From: WILLIFORD Dennis (AREVA) [Dennis.Williford@areva.com]
Sent: Thursday, May 30, 2013 10:16 PM
To: Snyder, Amy
Cc: Ford, Tanya; ANDERSON Katherine (EXTERNAL AREVA); DELANO Karen (AREVA); HONMA George (EXTERNAL AREVA); LEIGHLITER John (AREVA); LEWIS Ray (EXTERNAL AREVA); ROMINE Judy (AREVA); RYAN Tom (AREVA); SHEPHERD Tracey (AREVA); VANCE Brian (AREVA); NOXON David (AREVA); GUCWA Len (EXTERNAL AREVA); RITCHEY Calvin (AREVA)
Subject: Advanced Response to U.S. EPR Design Certification Application RAI No. 455, FSARCh. 19, OPEN ITEM, Question 19-341
Attachments: Advanced Response RAI 455 Q19-341 US EPR DC.pdf

Advanced Response to

Request for Additional Information No. 455, Question 19-341

Question 19-341:**OPEN ITEM****Follow-up to Open Item RAI No 234, Question 19-304**

Figure 19-341-01—U.S. EPR CSDRS

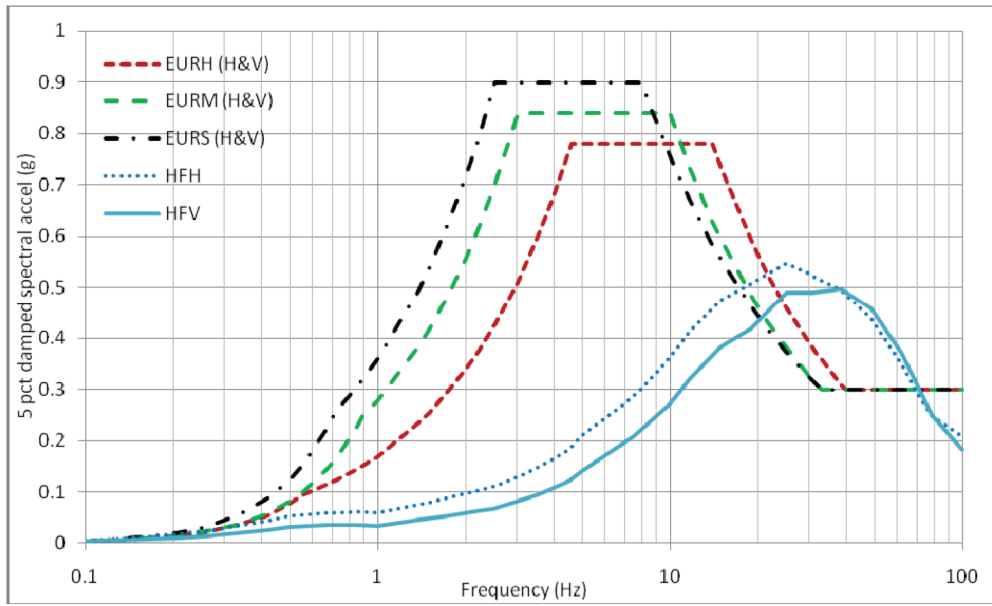
To ensure that the COL applicants are able to meet Section 52.79(a)(46) and §52.79(d)(1), revise the COL information items 19.1-6 and 19.1-7 to require: 1) COL applicants to update the DC's PRA-based SMA to address plant- and site-specific features, and 2) COL holders (licensees) to perform as-built verifications of the plant level HCLPF capacities. The COL applicants should identify plant-specific vulnerabilities and confirm the key assumptions and bases of the DC's SMA applicable to the site. If the plant-level HCLPF is less than the target value of 1.67 times the site-specific GMRS, the applicant should perform a full convolution of sequence fragility for all sequences with a potential to lead to core damage to demonstrate that the seismic risk is acceptably low for the licensed plant. ISG-20 provides guidance on this process in Section 5.1.4, and the detailed guidance for COL updating is provided in Section 5.2.

The CSDRS of the U.S. EPR standard plant consists of three EUR control motions anchored to 0.3 g peak ground acceleration, and a fourth high-frequency (HF) control motion. The vertical EUR control motions are the same as the horizontal EUR motions. The high frequency horizontal (HFH) and the high frequency vertical (HFV) control motions are anchored to 0.21 g and 0.18 g peak ground accelerations, respectively. The horizontal and vertical CSDRS are provided in Figure 19-341-01. For design certification, the CSDRS is the safe shutdown earthquake (SSE) per RG 1.208. U.S. EPR FSAR Tier 2, Figure 19.1-31 will be deleted and a reference to the CSDRS description in U.S. EPR FSAR Tier 2, Section 3.7.1 will be added.

Tier 2, Section 19.1.5.1.1, equation (A). The seismic margin, which is defined by the ratio of the HCLPF capacity to the CSDRS PGA of 0.3 g, will be shown equal to or greater than the 1.67 value noted in ISG-20. Because the enveloping seismic response for all the soil profiles is used in the seismic fragility derivation, this seismic margin is applicable to the spectral shape of the CSDRS.
